QUESTIONS ON WATERFORD 3 BASEMAT
3/26 MEETING IN BETHESDA

Allegations recently reported in a GAMBIT newspaper article and in staff investigations concerning the GAMBIT article have lead to the assignment of additional reviewers to evaluate the base mat adequacy. This transmittal is a composite set of Questions from the reviewers, and is intended to faciliate LP&L's preparation for the meeting on March 26, 1984 in Bethesda.

CHKD. BY _____ DATE _____
 CLIENT LOUISIANA POWER & LIGHT COMPANY

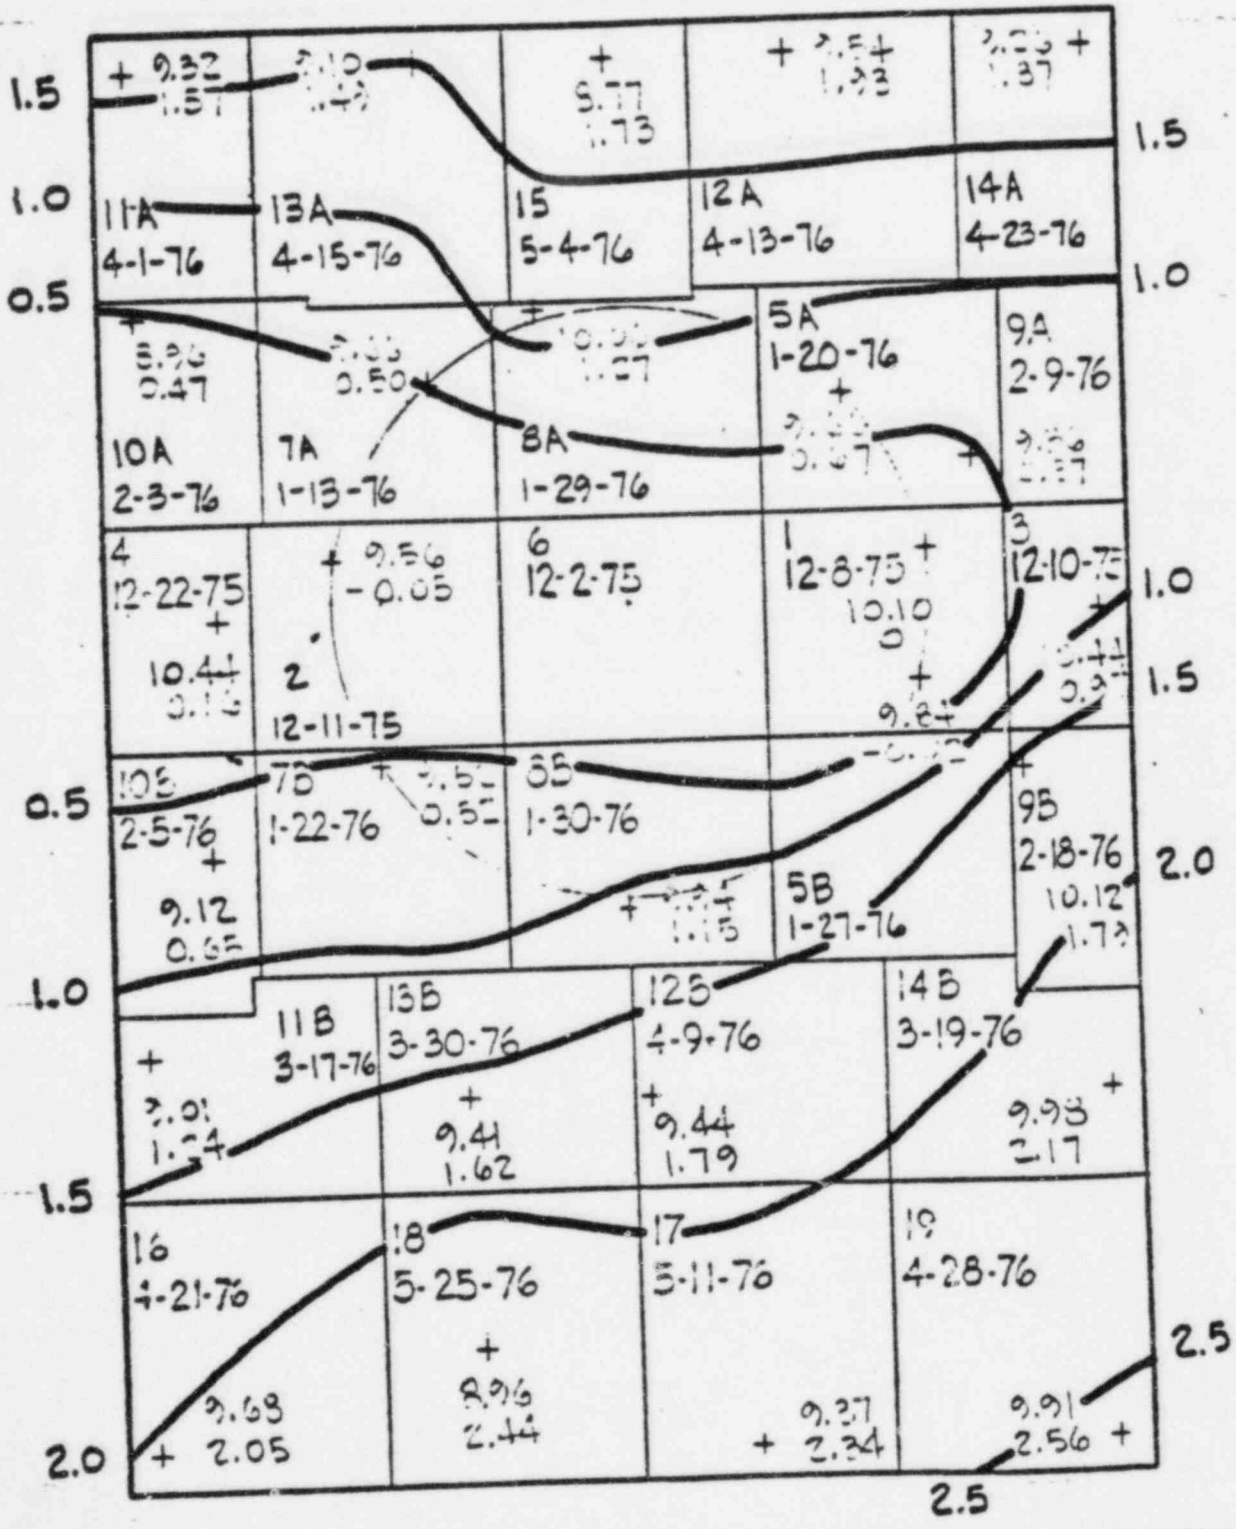
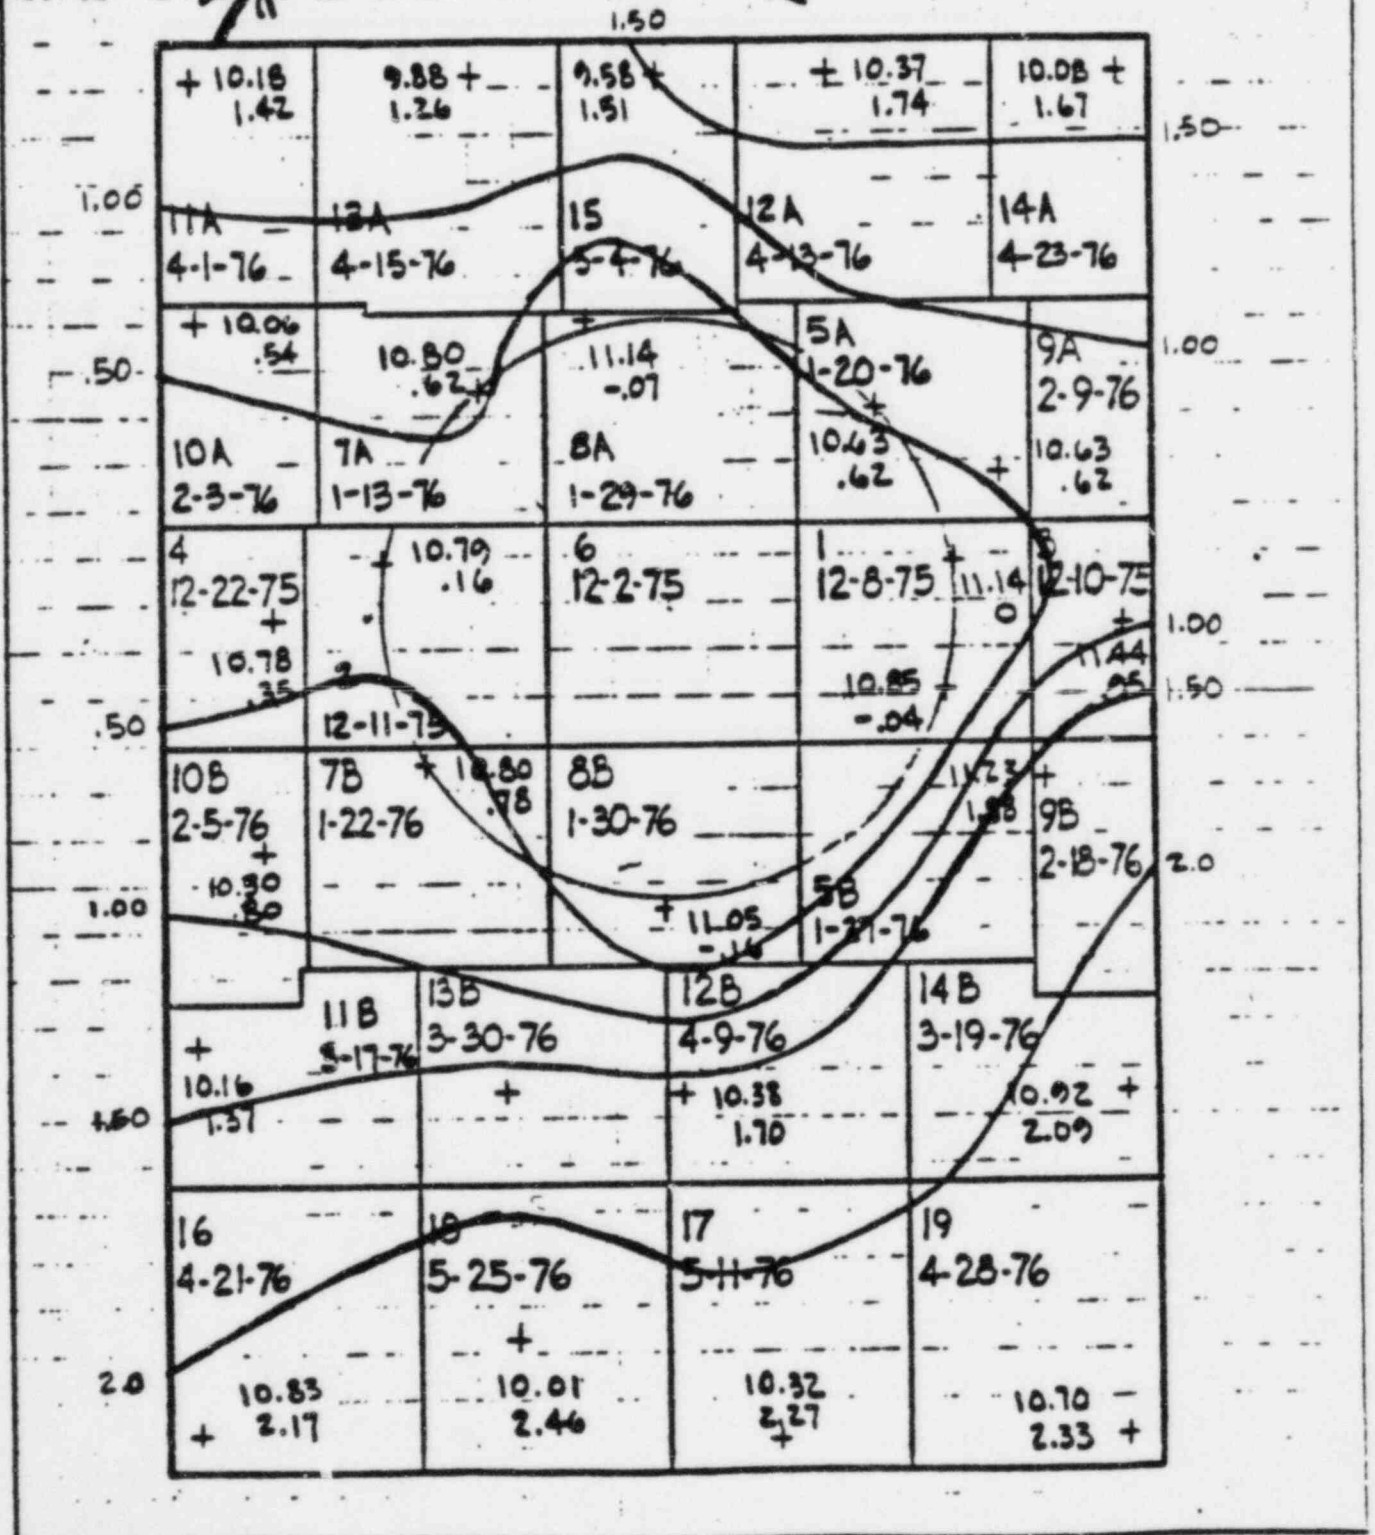
17. Provide differential settlement contours for 6 month periods, starting from early 1977 to present.

Response:
